SOUNDTRANSIT

ST3 COST ESTIMATE & GENERAL ASSESSMENT SERVICES

TASK 1: Final Report of Significant Findings and Recommendations

APRIL 19, 2021

Ecology Figure 1

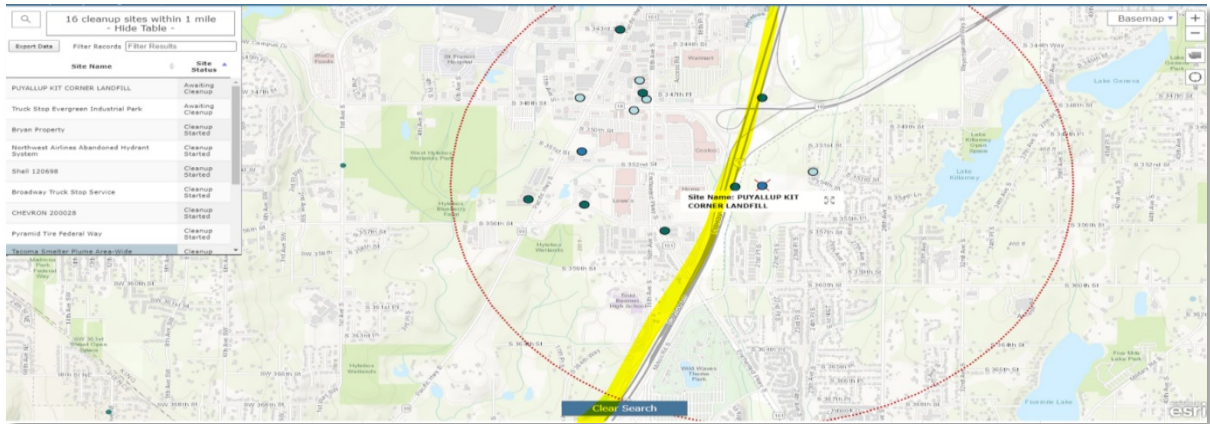
- Minimum effects to Hylebos Creek and Wapato Creek – preserving wetlands, trees, and vegetation.
- Minimum archaeological affect near Puyallup River for the Puyallup Tribe of Indians – cultural and human remains due to alignment type change

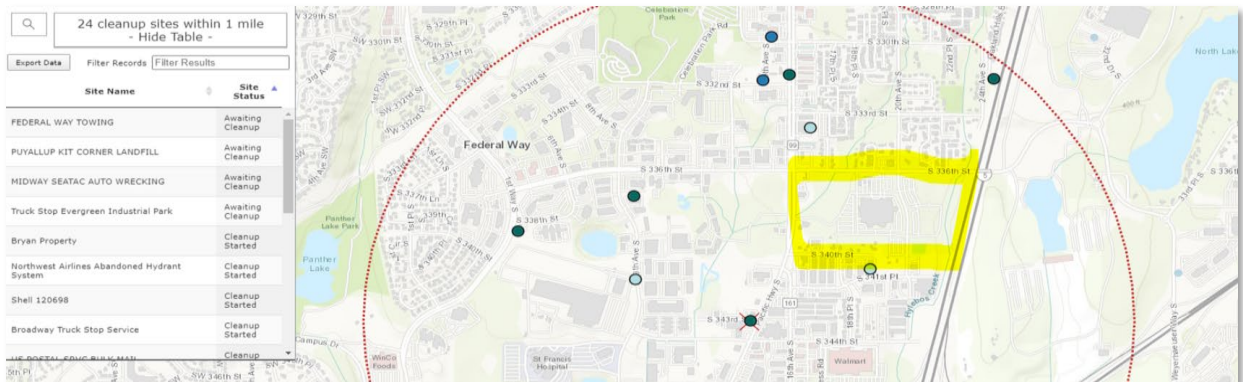
- Does WSDOT has wetland/mitigation bank in the neighborhood that can be used?
